**COLORADO**  
Division of Reclamation,  
Mining and Safety  
Department of Natural Resources

**Re: Third Adequacy Review, Revision No. TR-140, Cresson Project, Permit No. M-1980-244**

**ATTACHMENT A – EXAMPLE 1**

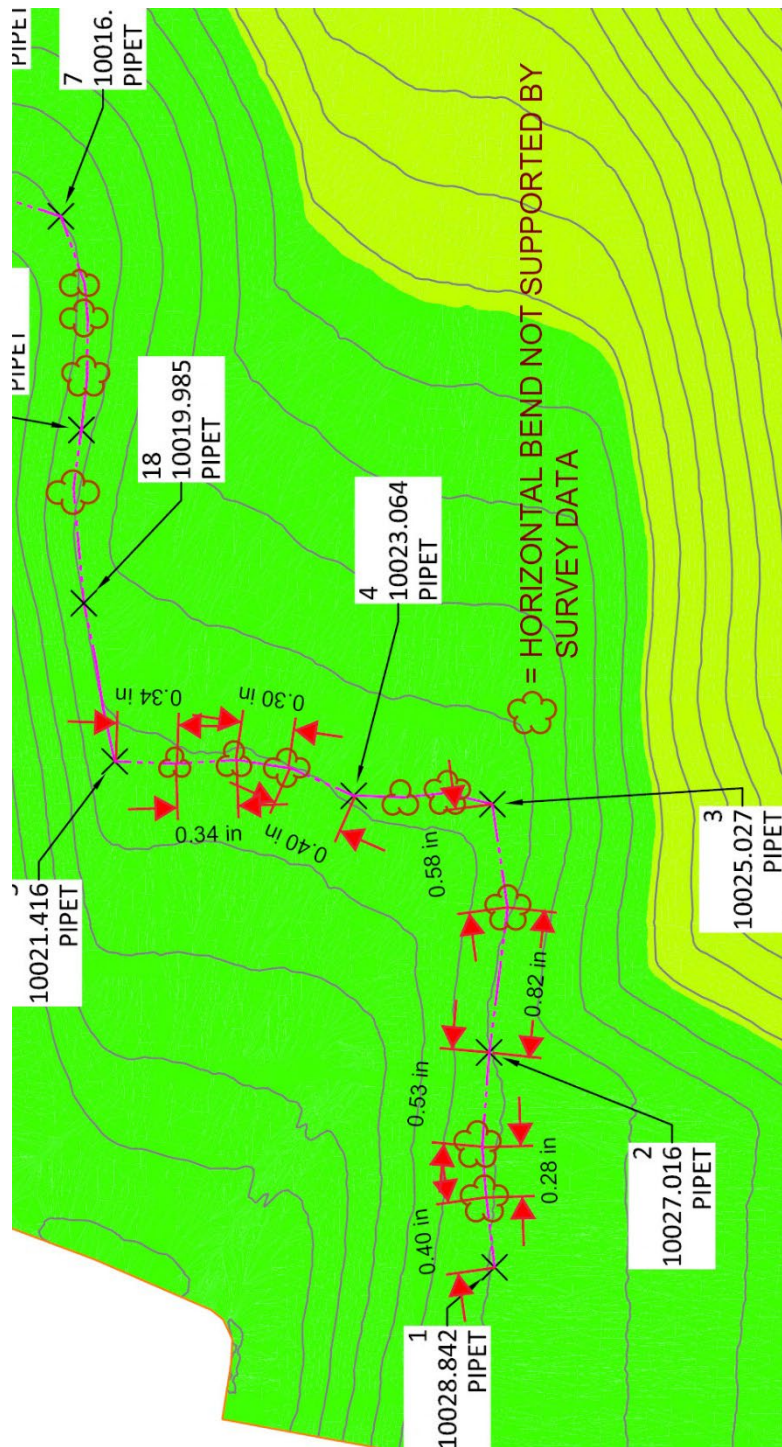
Please see the three examples in **Attachment A** depicting the unsupported horizontal bends presented in the Leak Detection Trench As-Built drawings. Based on the information received to date there is either additional survey data that has not been reported but supports the existence of the additional horizontal bends in the Record Drawings; or the Record Drawings do not reflect the as-constructed conditions of the

Leak Detection System (LDS) piping. Please explain the discrepancy and make the appropriate changes (either submit additional survey data and/or revise the record drawings) and resubmit to the Division.

12 Horizontal Bends (cloud circles) Not Supported by Provided Survey Data  
[from SHEET 3 LEAK DETECTION TRENCH 1 AS-BUILT; Drawing scale stated as 1" = 70']

**ATTACHMENT A – EXAMPLE 2**

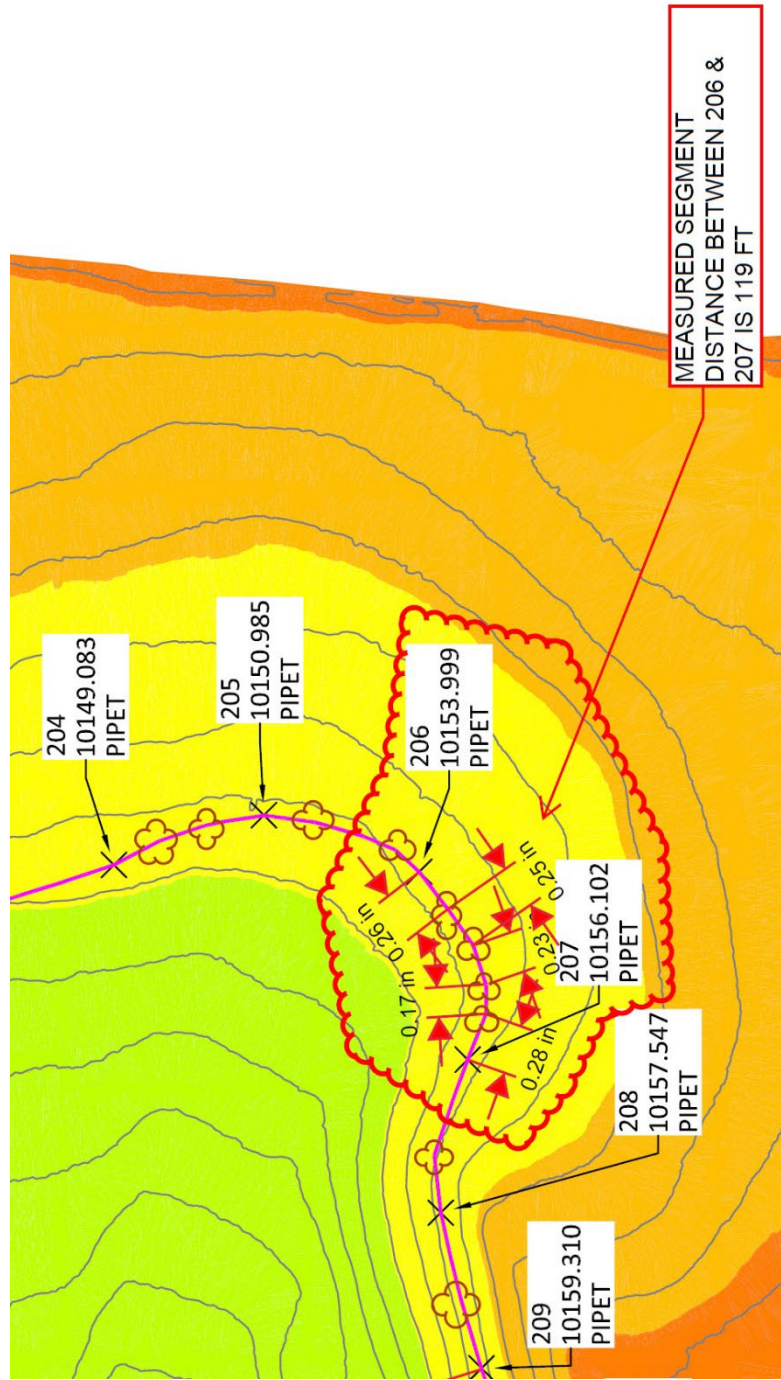
10 Horizontal Bends (cloud circles) Not Supported by Provided Survey Data  
[from SHEET 4 LEAK DETECTION TRENCH 2 AS-BUILT EXHIBIT; Drawing scale stated 1" = 100']

**ATTACHMENT A – EXAMPLE 3**

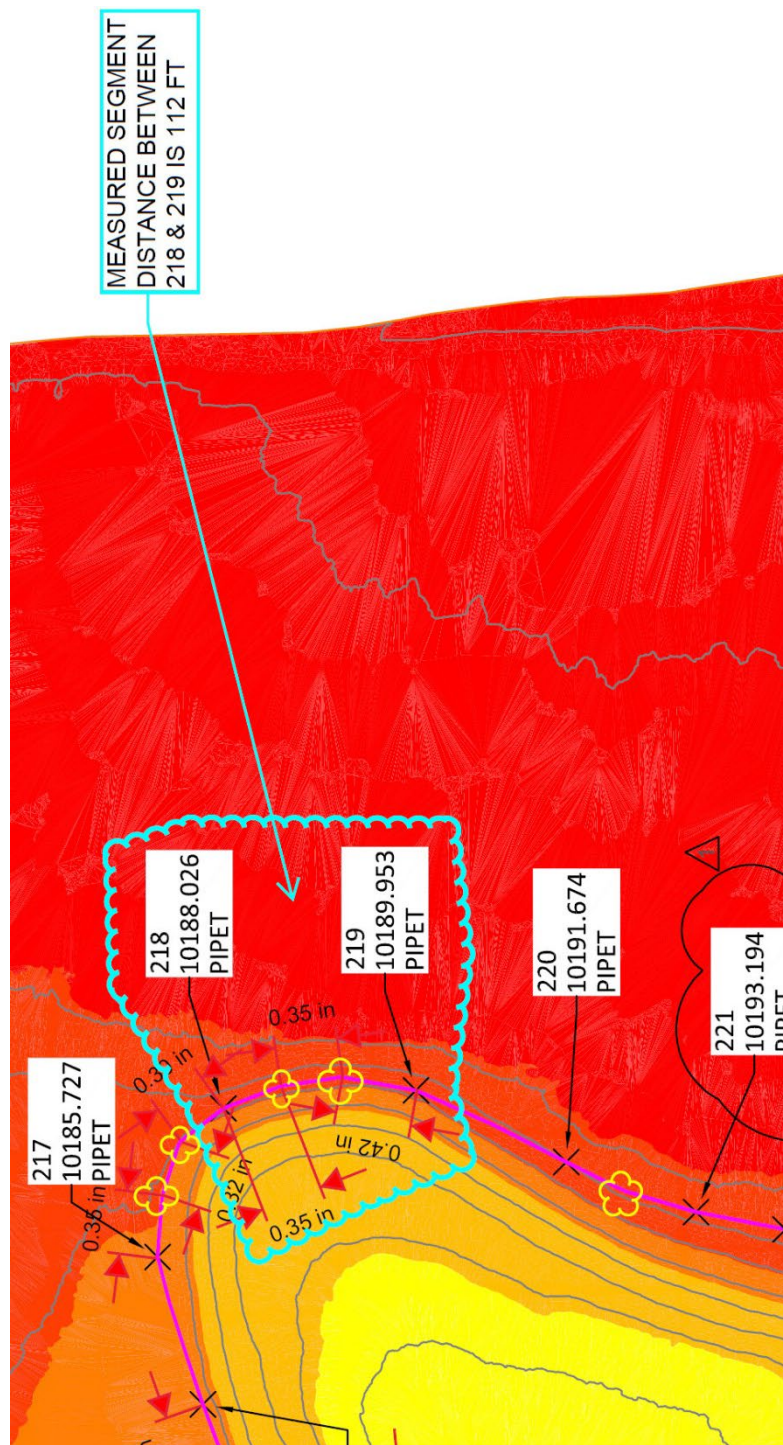
Five Horizontal Bends (cloud circles) Not Supported by Provided Survey Data  
[from SHEET 4 LEAK DETECTION TRENCH 2 AS-BUILT EXHIBIT; Drawing scale stated 1" = 100']
